**LATE ITEM P21/3943 AMENDMENT TO SINGLE HOUSE (SITE WORKS AND SCREENING) – LOT 802 (10D) BIRDWOOD CIRCUS, BICTON WA 6157 (REC) (ATTACHMENT)**

Ward : Bicton - Attadale - Alfred Cove  
 Category : Operational  
 Application Number : DA-2019-1200/B  
 Property : Lot 802 (10D) Birdwood Circus, Bicton WA 6157  
 Proposal : Amendment to a Single House (Site Works and Screening)  
 Applicant : Mr M J Tomasini  
 Owner : Mr M J and Mrs A R Tomasini  
 Disclosure of any Interest : No Officer involved in the preparation of this report has a declarable interest in this matter.  
 Previous Items : None  
 Responsible Officer : Peter Prendergast  
 Manager Statutory Planning

**P21/3943 AMENDMENT TO SINGLE HOUSE (SITE WORKS AND SCREENING) – LOT  
802 (10D) BIRDWOOD CIRCUS, BICTON WA 6157 (REC) (ATTACHMENT)**

Figure 4 – Blade wall location shown in red

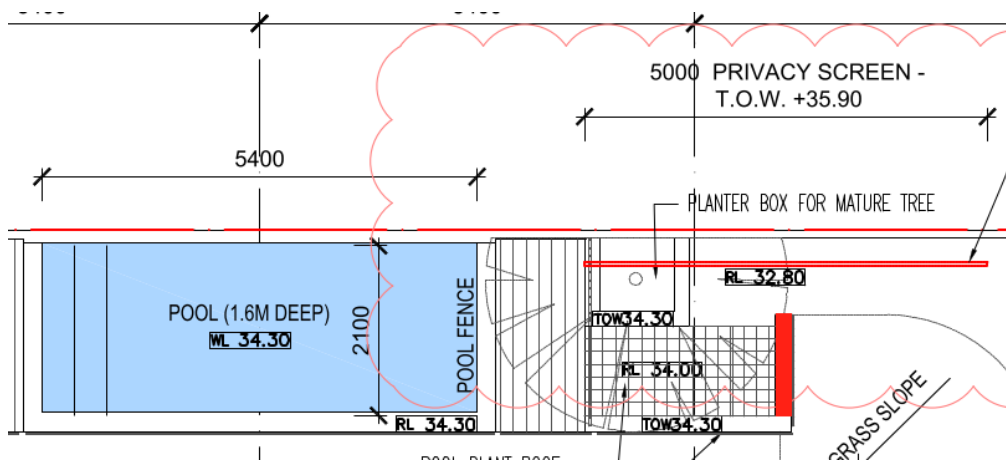
As outlined in the table above, the setback of the blade wall which forms part of the retaining wall of the subject site does not meet the deemed-to-comply provisions of the R-Codes and therefore requires a performance assessment. The proposed retaining wall setback is considered to meet the Design Principles of the R-Codes for the following reasons:

- Overall, the retaining wall setbacks meet the deemed-to-comply criteria, except for a blade wall which forms part of the pool pump/storage area. The blade wall is located behind the existing fence ensuring the wall will not add excess building bulk on to the adjoining northern property, or be seen from the street. The subject blade wall is setback 1m from the northern lot boundary in lieu of 2m;

- The approved dwelling meets the R-Codes deemed-to-comply criteria for solar access and ventilation. Therefore access to direct sunlight and ventilation on the adjoining northern property is not restricted;

- The site slopes by approximately 5 metres from the street to the rear lot boundary. The site works respond to the natural contours of the site, and the fill and retaining walls allow for a level outdoor living area creating a useable space for the occupants of the dwelling.

- The blade wall is located next to the adjoining property's service access leg and swimming pool and is not located next to the primary outdoor living area. The wall will not be visible from habitable rooms of the adjoining property as the boundary fence screens the retaining wall from view. All habitable rooms of the adjoining property are oriented towards the north and east and not towards the subject site; and

Figure 5 – Screen wall showing detail of restricted cone of vision

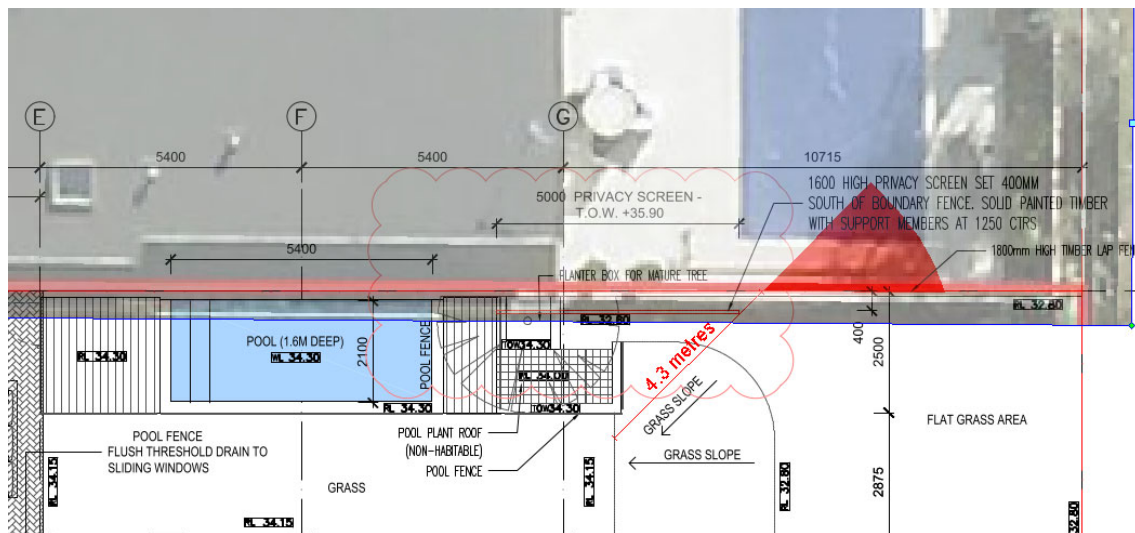
As outlined in the table above, the proposed fill associated with site works creates a ground level greater than 0.5m height above natural ground level. This does not meet the deemed-to-comply provisions of 5.4.1 C1.1 and therefore requires a performance assessment. The height and length of the proposed screen wall is considered acceptable and adequate visual privacy is maintained for the adjoining property for the following reasons:

- The proposed screening ensures minimal direct overlooking of the pool area of the adjoining property. As depicted in the Figure 5 below, views are directed to the rear corner of the lot, ensuring the secondary living area and the majority of the pool area are maintained as private space; and
- The adjoining property to the north is designed with its primary outdoor living area orientated to the northern side of the dwelling. This ensures that the outdoor living area is not impacted by the current proposal. The proposed site works do not result in any overlooking of major openings to the adjoining property as it has been designed with highlight windows facing south, and its site has major openings facing east towards the swimming pool, or north towards the alfresco.

- A) The previous planning approval DA-2019-1200/A dated 12 August 2020 (including remaining conditions);**
- B) The enclosed approved plans (referenced Site Plan, Ground Floor Plan, First Floor Plan and Elevations) stamped as approved on 26 July 2021;**
- C) Additional condition 13 be added:**
  - 13. The privacy screen shown on the approved plans (marked in red) shall meet the Deemed to Comply standards of Cl. 5.4.1 of the Residential Design Codes. The privacy screen shall be installed prior to initial occupation of the development and thereafter retained in perpetuity to the ongoing satisfaction of the City.**
